PHASE 1C PRELIMINARY LAND DEVELOPMENT PLAN REVIEW LETTER #1

MIDDLESEX TOWNSHIP, CUMBERLAND COUNTY, PA

Preliminary Land Development Plan for Pennsylvania Digital 1 (PAX-1) Phase 1-C

Middlesex Twp. Plan No. TPF 26-10

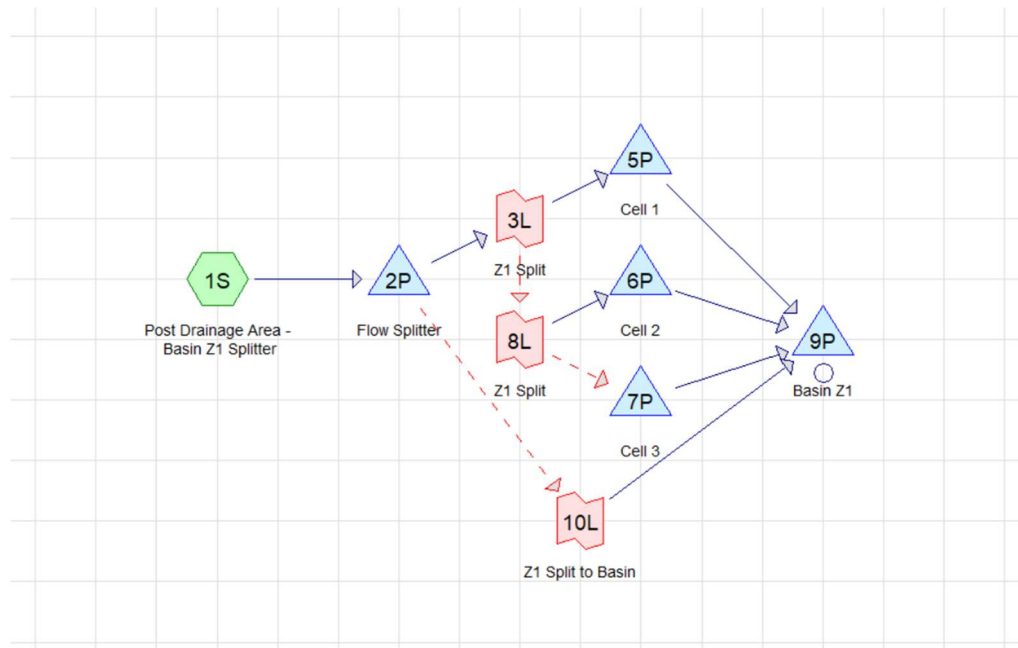
28. The HydroCAD routing diagram utilizes a link to split the MRC inflow hydrographs into the three MRC cells. It appears that this may be better modeled as the inflow hydrograph going to a single MRC overflow structure and then split using the link. This would eliminate the need to model three separate flow splitter structures when there is only one proposed. This may also address the comment above. See diagram below for clarity [302.D].
